6G SAS
RX Tolerance, Reference RX &
Reference TX

Mike Jenkins
LSI Corporation

Table 60 — Receiver device jitter tolerance at receiver device compliance points IR and CR
Mike Jenkins to update for 6Gbps

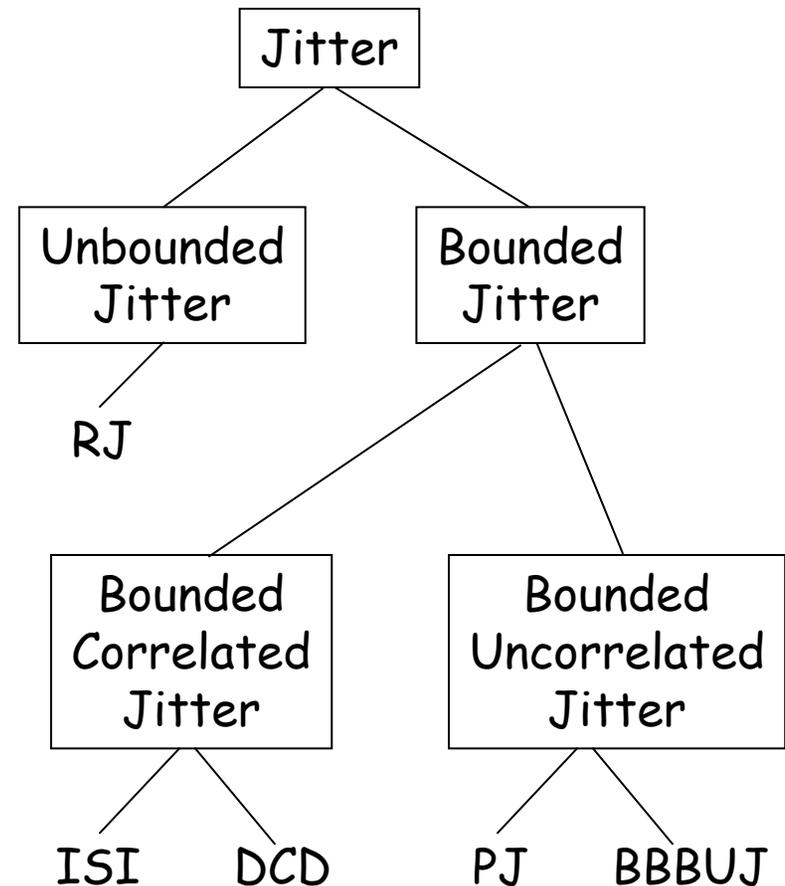
Modify note k to something like:

“For 6 Gbps, TJ is measured at the reference RX output, then disconnected and connected to the RX under test”

Req'd RX (post-EQ) Eye Opening

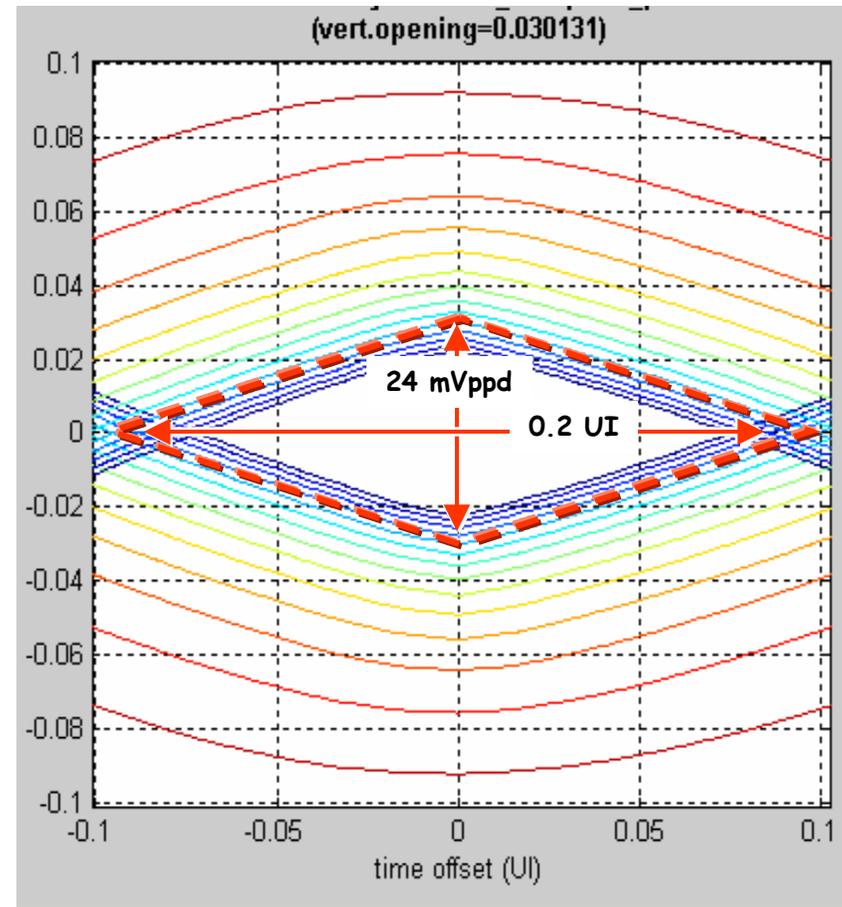
- Eye virtually closed by present impairments (but see following slide)
- With $RJ=DJ=0.10 UI$, eye opens as shown →
 - Note vertical opening $\sim 1/3^{\text{rd}}$ of typical spec
- Need for voltage amplitude to provide RX noise margin
